ADDENDUM NUMBER 4

- 1.01 DATE: MAY 25, 2018**
- 1.02 PROJECT: AUSTIN HIGH SCHOOL CAREER TECH CENTER**
- 1.03 PROJECT NUMBER: B. C. NO. 2018112**
- 1.04 OWNER: DECATUR CITY SCHOOLS**
- 1.05 ARCHITECT: NOLA | VAN PEURSEM ARCHITECTS, PC**

4.01 SHEET M-2.1 – MECHANICAL ROOF PLAN:

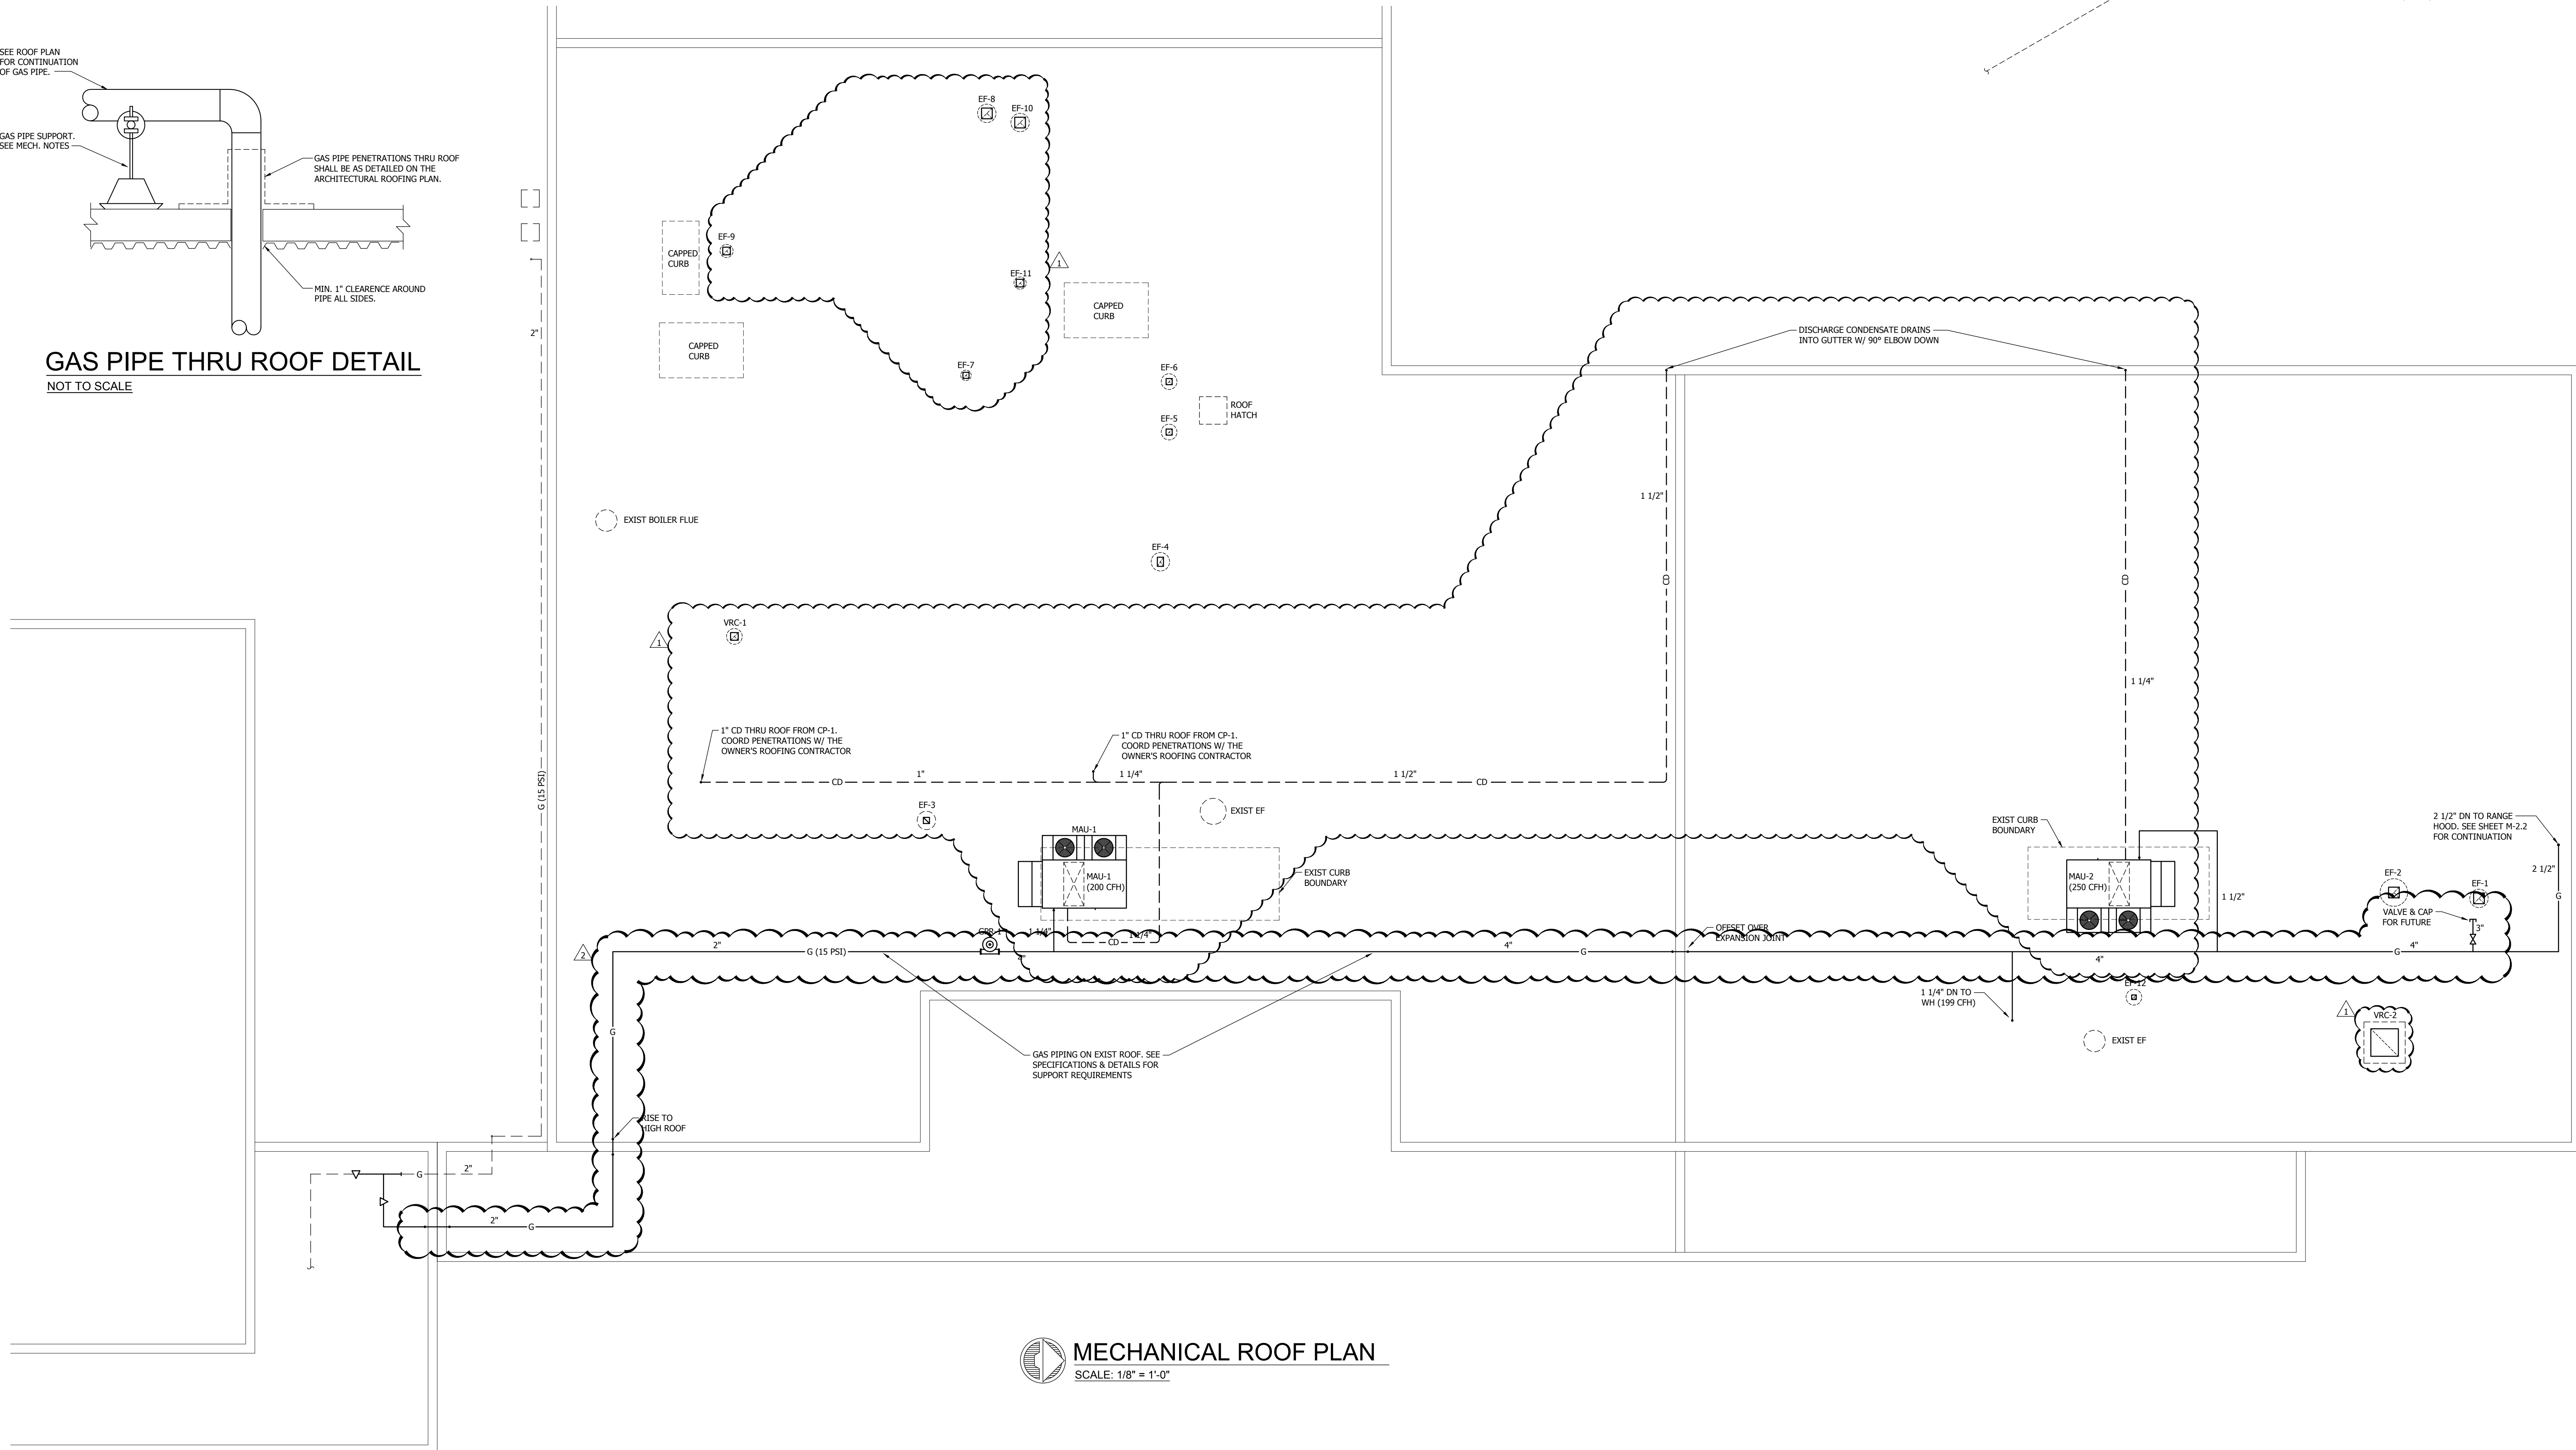
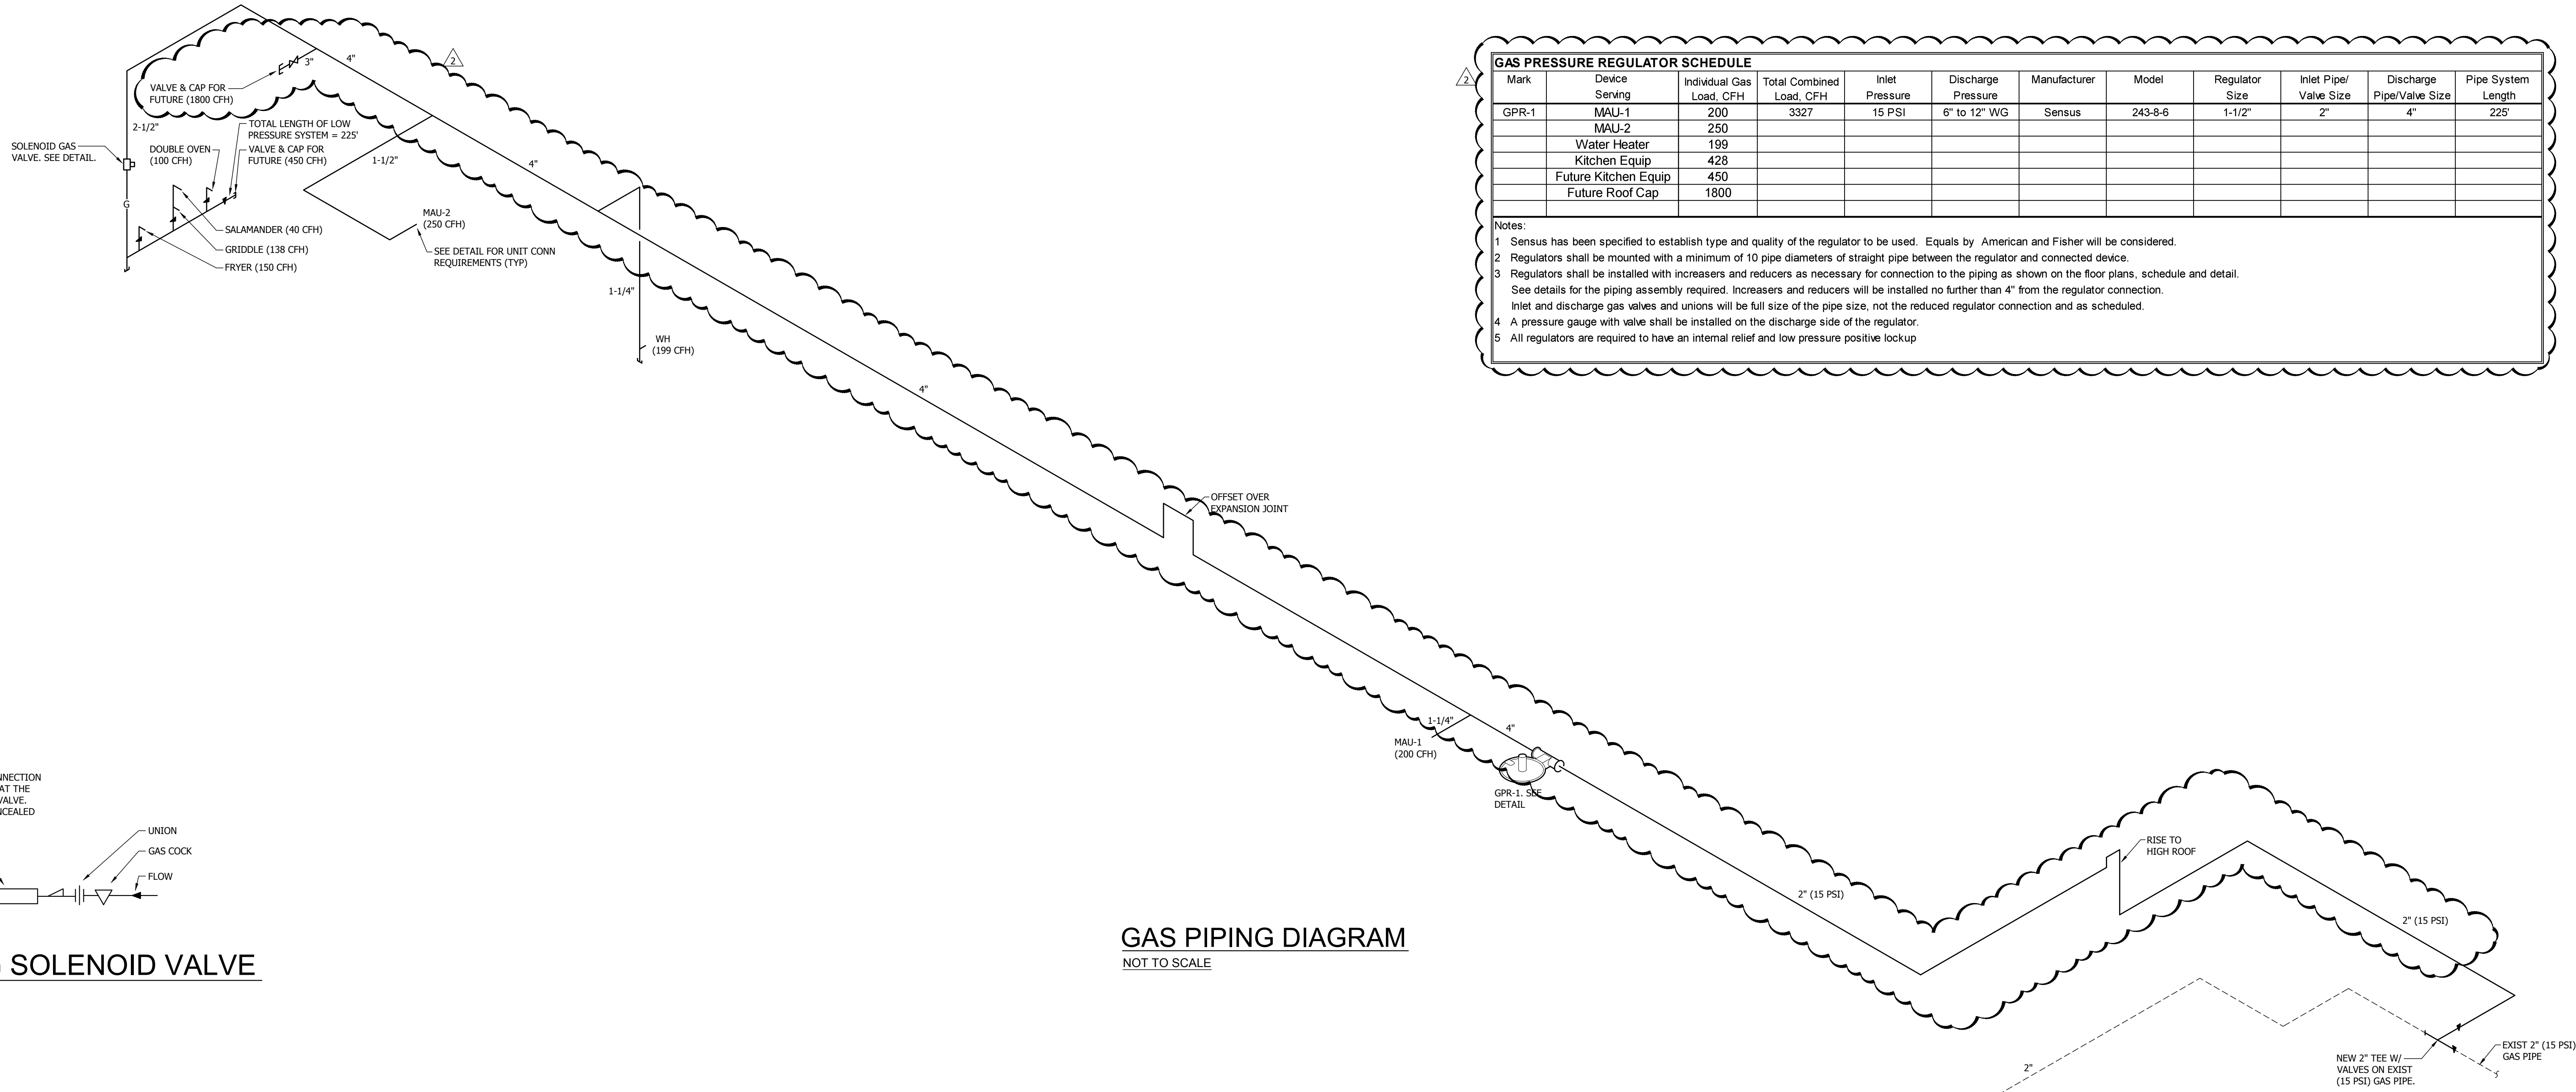
- A. Replace this sheet in its entirety, the list of changes are as follows:
 - 1. Gas piping sizes have been increased to accommodate a valve and cap for future on the roof above the Culinary area.
 - 2. Gas Pressure Regulator has been moved from the schedules sheet to this sheet to show all gas pipe and regulator requirements.
 - 3. Gas Regulator schedule has been revised.
